SUBJECT: ISSUANCE OF AMENDMENT - EDWIN I. HATCH NUCLEAR PLANT, UNIT 1  
(TAC NO. M98387)

EDWIN I. HATCH NUCLEAR PLANT, UNIT 1

AMENDMENT TO FACILITY OPERATING LICENSE

Amendment No. 207  
License No. DPR-57

Figure 3.4.9-1 (Page 1 of 1)  
Pressure/Temperature Limits for  
Inservice Hydrostatic and Inservice Leakage Tests

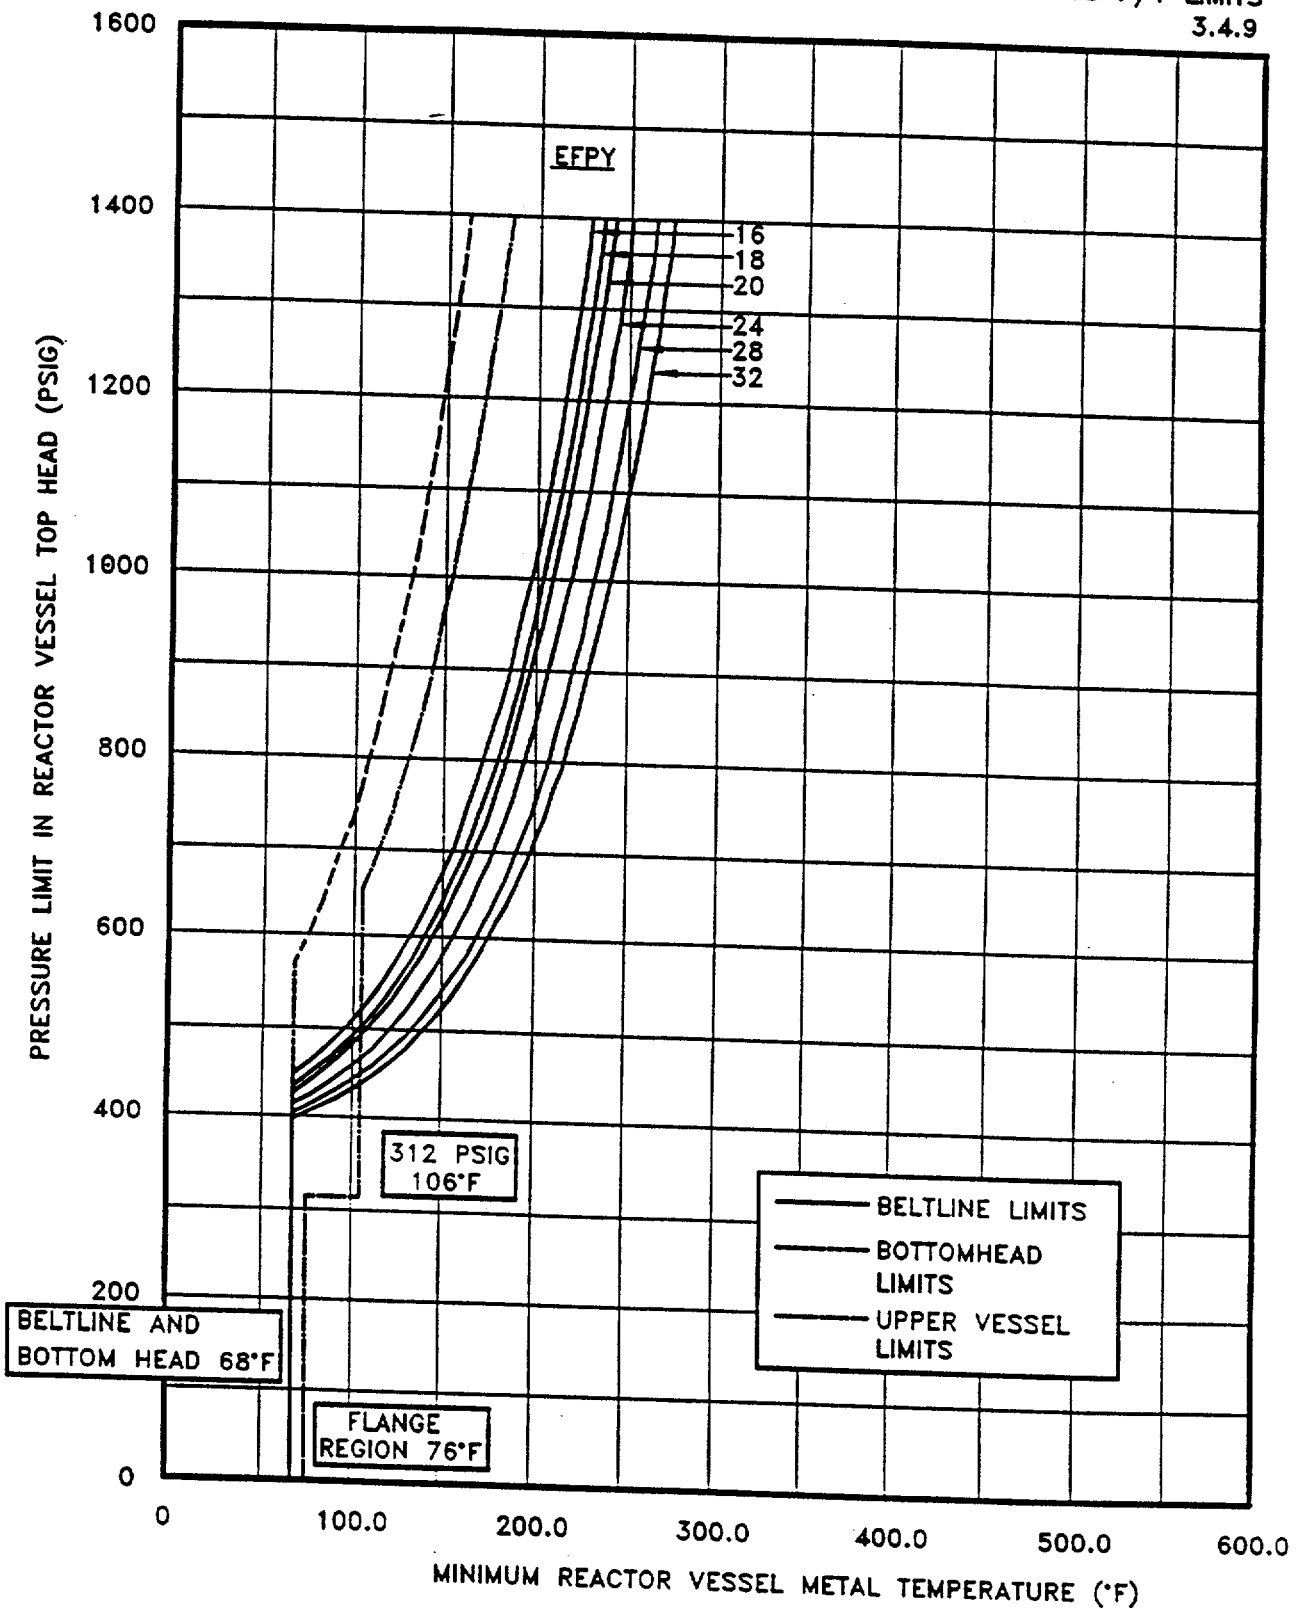
The amendment revises the Hatch Unit 1 reactor vessel pressure and temperature limits to reflect data collected from the material sample recovered during the March 1996 Unit 1 outage.

Replace the following pages of the Appendix "A" Technical Specifications with the enclosed pages. The revised pages are identified by Amendment number and contain vertical lines indicating the areas of change.

Substituting the ART values for the Hatch Unit 1 limiting plate into equations in SRP 5.3.2, the staff verified that the proposed P-T limits satisfy the requirements in Paragraph IV.A.2 of Appendix G of 10 CFR Part 50.

The staff has performed an independent analysis to verify the licensee's proposed P-T limits. The staff concludes that the proposed P-T limits are valid to 32 EFY since the limits conform to the requirements of Appendix G of 10 CFR Part 50 and GL 88-11. Hence, the proposed P-T limits may be incorporated in the Hatch Unit 1 Technical Specifications.
